## **ADDENDUM No. 1**

Project: **Gear Replacement  
FAMU – Foster Tanner**

Project Number: **2023-085**

Date: **April 30, 2024**

**ELECTRICAL GENERAL NOTES, LEGEND AND SCHEDULES**

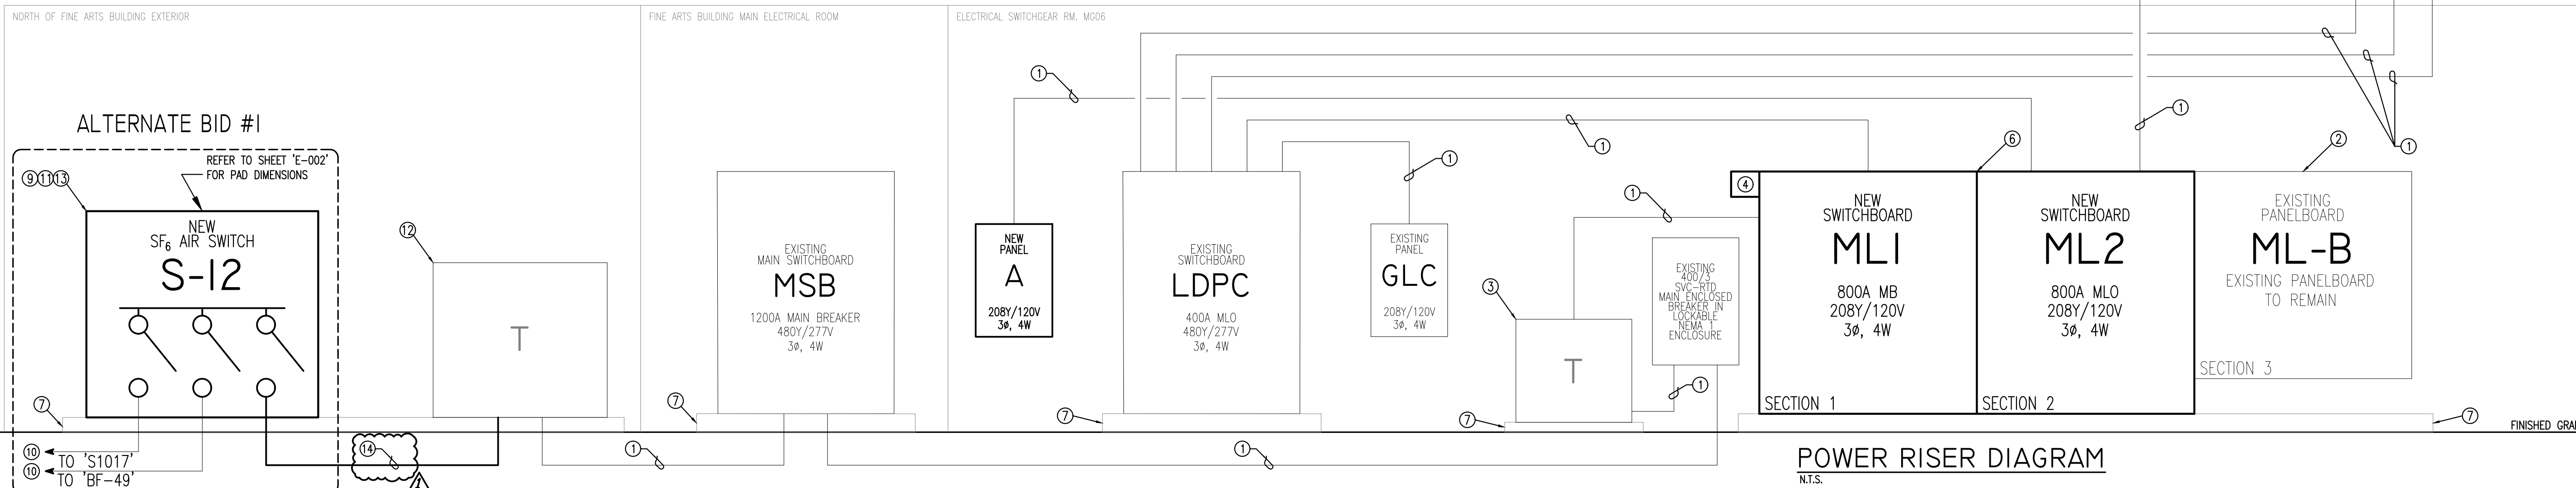
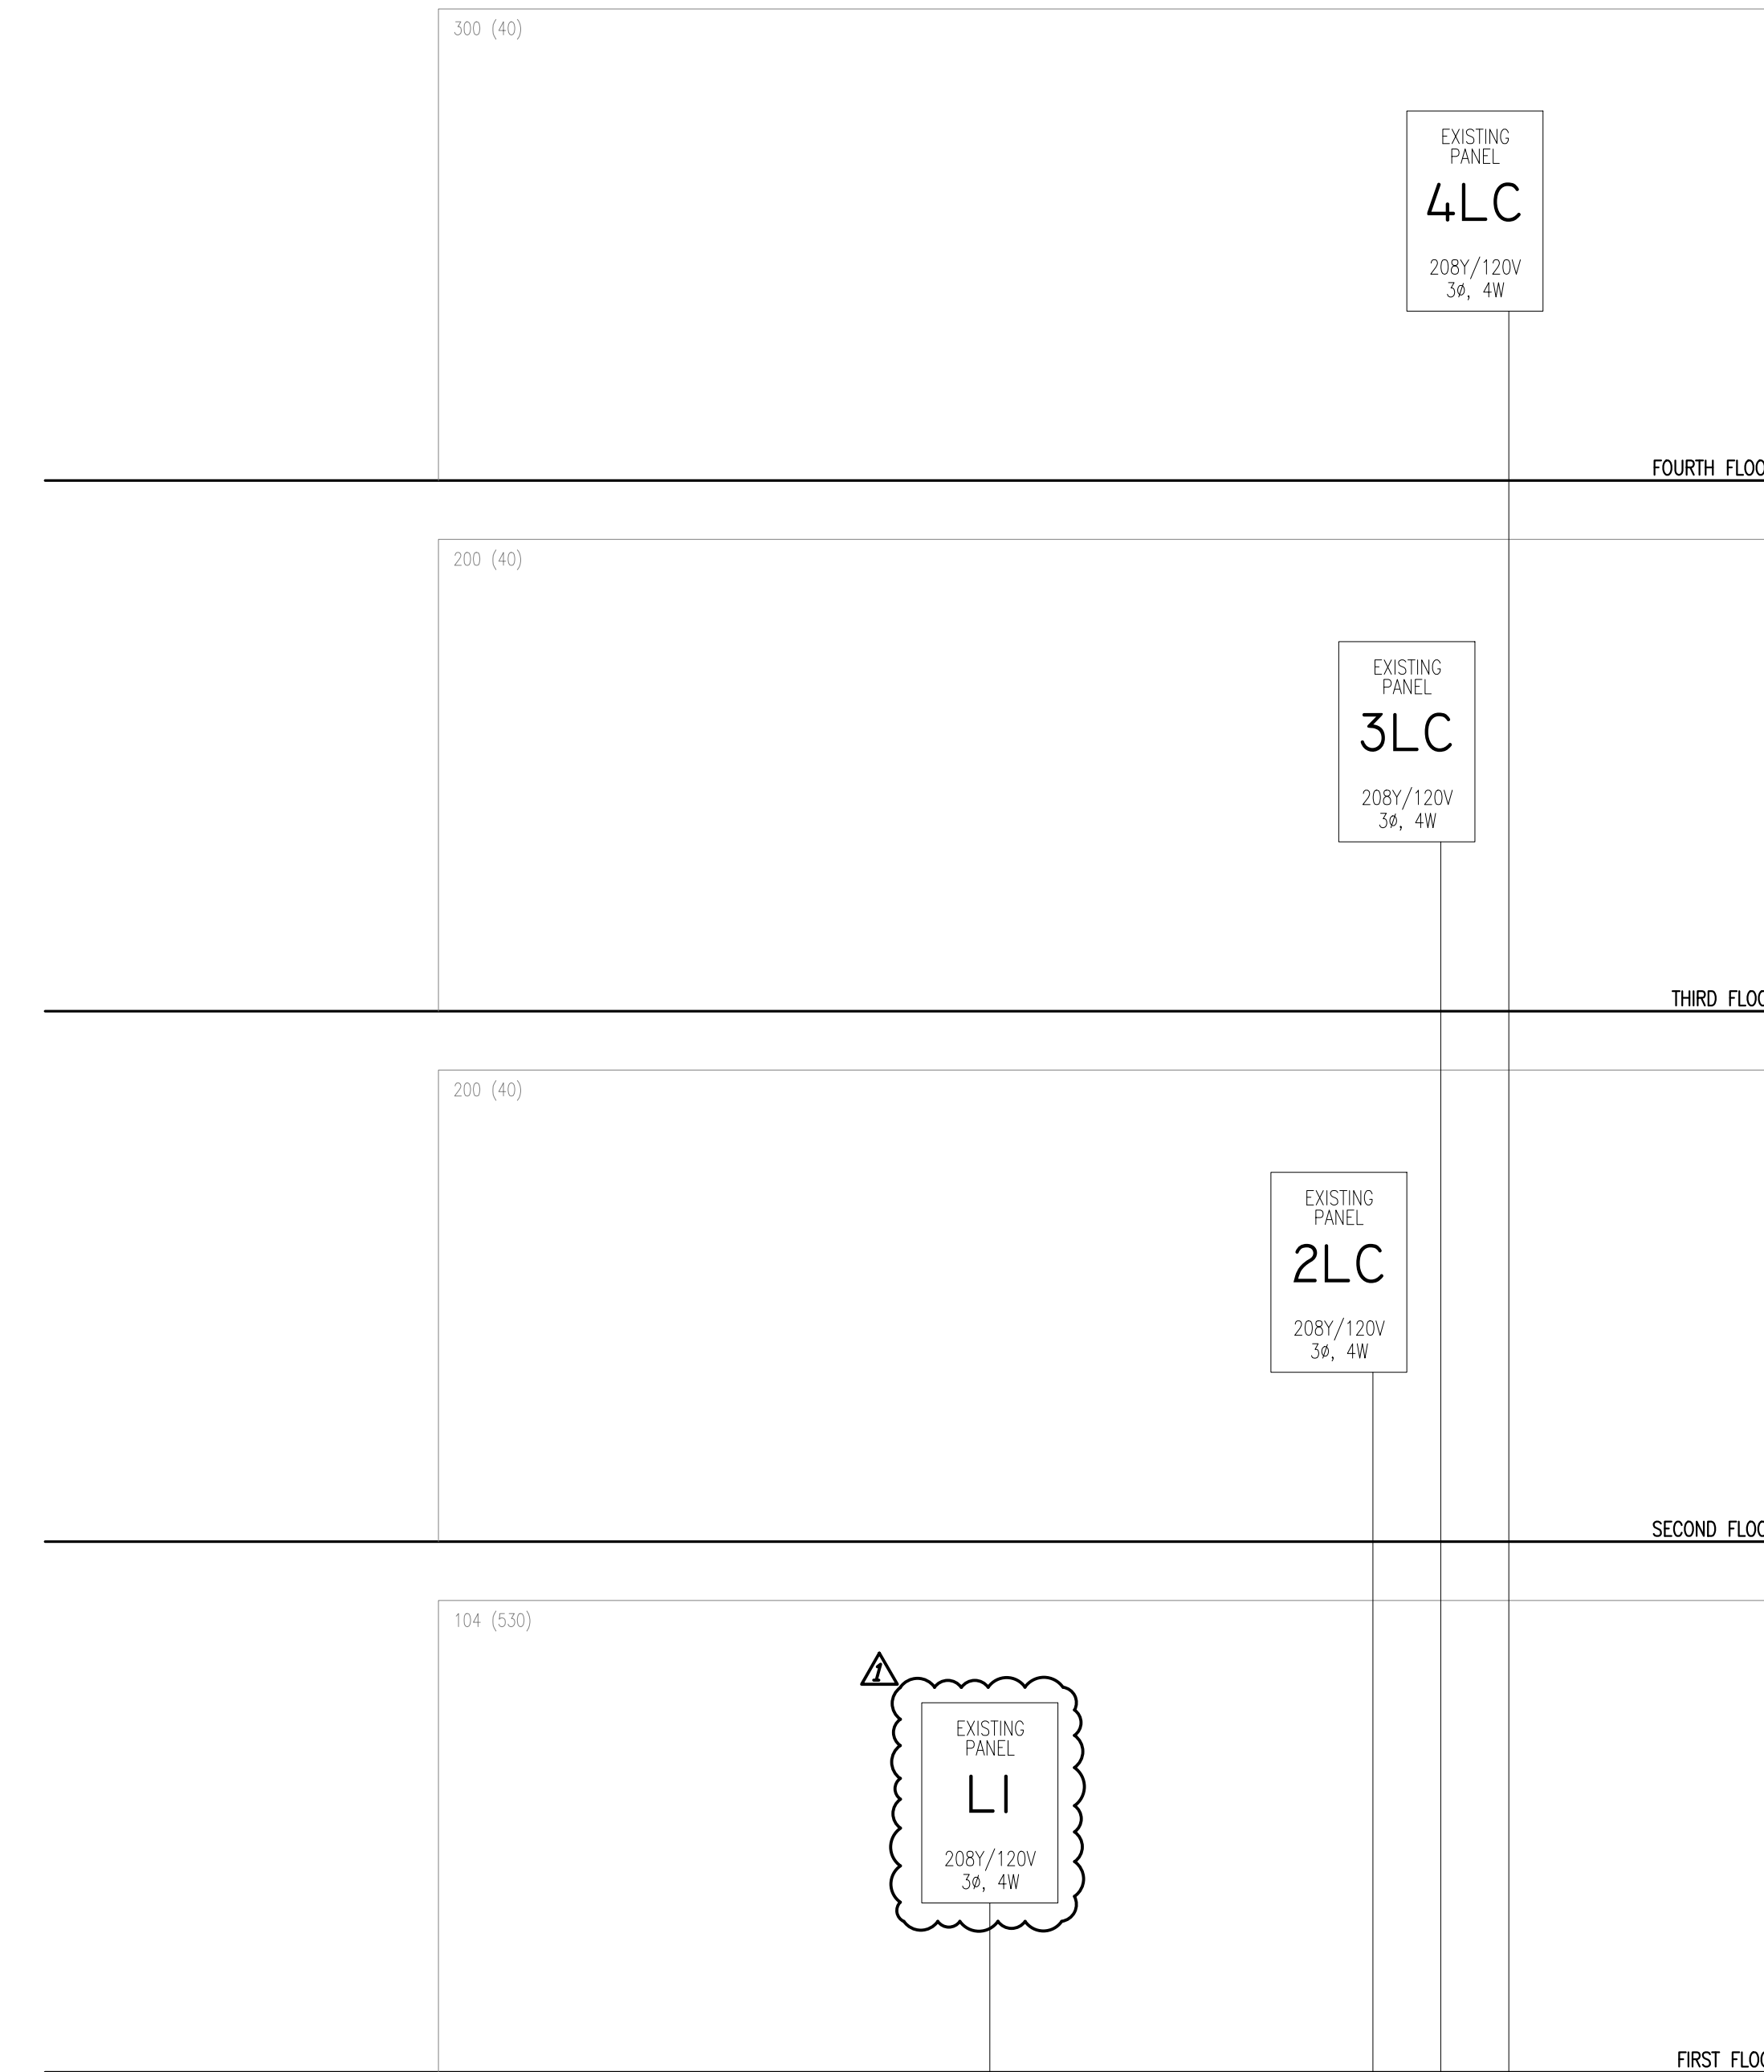
Item #D1: Sheet E-001 Electrical General, Notes, Legend, and Schedules:

1. Panel 'L1' shown to be existing to remain and not to be replaced.
2. Additional Keynotes added for Alternate Bid #1. See keynotes #11-14.
